Other Regulations – Regulation No. 87 (Daytime running lamps)

Proposal for Supplement 18 to Regulation No. 87 (Daytime running lamps)

Submitted by the expert from the International Automotive Lighting and Light Signalling Expert Group (GTB)*

Figure 1

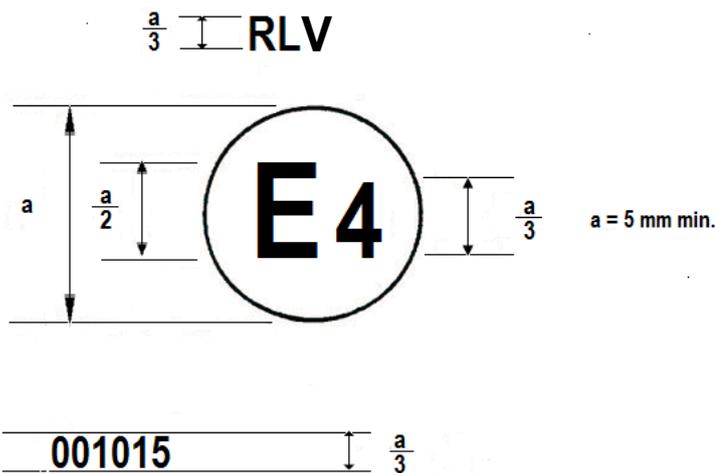
Annex 2., figure 1 and its corresponding text, amend to read:

The daytime running lamp **with variable luminous intensity** bearing the approval mark shown above has been approved in the Netherlands (E 4) under number 001015. The approval number indicates that the approval was granted according to the requirements of this Regulation in its original (unamended) form.
